Drawing Title
PASSING PLACE A3_P_4 GENERAL ARRANGEMENT

East West Rail Phase 2

Stage 2 Road safety audit response report

Offline Highways Passing Places – Package 2 – Oxfordshire (A3 Marsh Gibbon – Compound Access)

PASSING PLACE A3_P_4 EXISTING UTILITIES AND SITE CLEARANCE

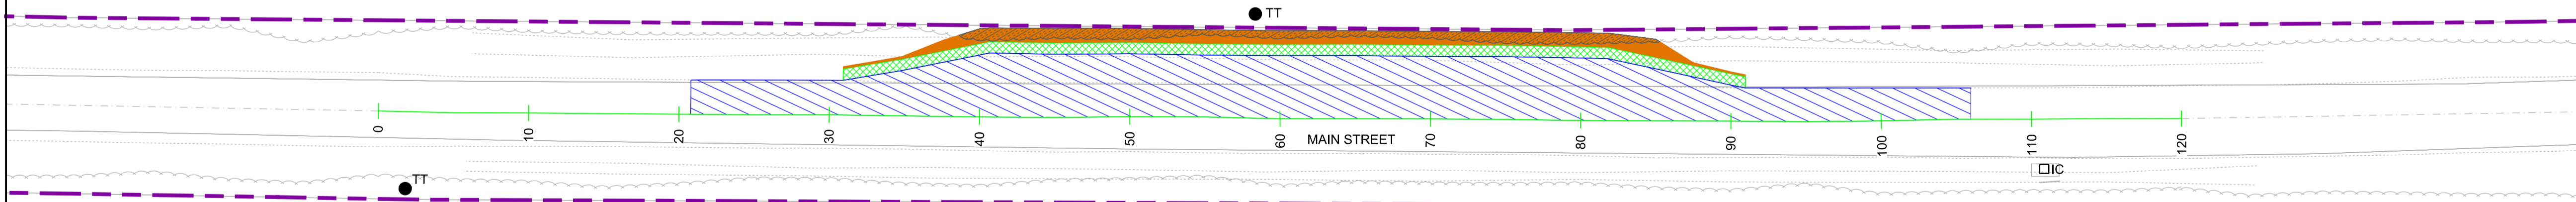
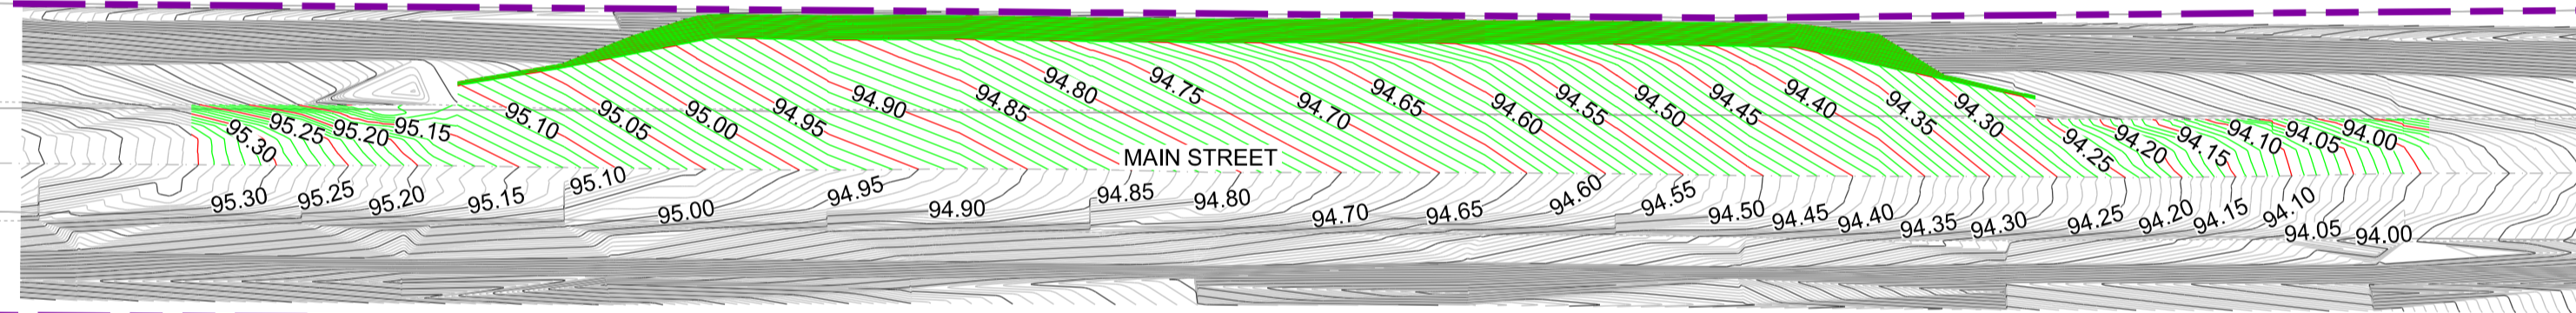
Passing places are proposed in positions where vegetation may restrict drivers' visibility of the route and the visibility of vehicles using the passing places. With this limitation, drivers of construction vehicles may not be aware that they should wait and might proceed, increasing the risk of side swipe collisions, or the risk of vehicles leaving the carriageway

The existing vegetation should be cut back to ensure clear visibility to all traffic signs and to keep the carriageway clear from obstructions.

| RSA Ref | Location | RSA Problem | RSA Recommendation | Design Team Response | Network Rail Response | Agreed RSA action |
|---------|--|---|---|---|-----------------------|---------------------------------|
| 2.5 | <p>Passing Places A2-P-2, A3-P-2, A3-P-3, A3-P-4, A3-P-5, A3-P-6, A3-P-7, A3-P-8, A3-P-9 and A3-P-10. Unnamed Road (towards Mill Road) and Unnamed Road.</p> | <p>Driver visibility reduced by vegetation Passing places are proposed in positions where vegetation may restrict drivers' visibility of the route and the visibility of vehicles using the passing places. With this limitation, drivers of construction vehicles may not be aware that they should wait and might proceed, increasing the risk of side swipe collisions, or the risk of vehicles leaving the carriageway on narrower sections of carriageway. Additionally, drivers of approaching vehicles may not anticipate the construction vehicle leaving the passing place, leading to side swipe or head on collisions. There is further risk that existing vegetation will encroach into the carriageway increasing the risk of damage to vehicles and HGVs being pushed towards oncoming traffic.</p> | <p>The existing vegetation should be cut back to ensure clear visibility to all traffic signs and to keep the carriageway clear from obstructions.</p> | <p>Accept the RSA problem and recommendation made by the RSA team. The site clearance drawings include vegetation clearance to achieve required visibility and signage strategy drawings likewise include this provision.</p> | Accepted | Proceed as Design Team Response |
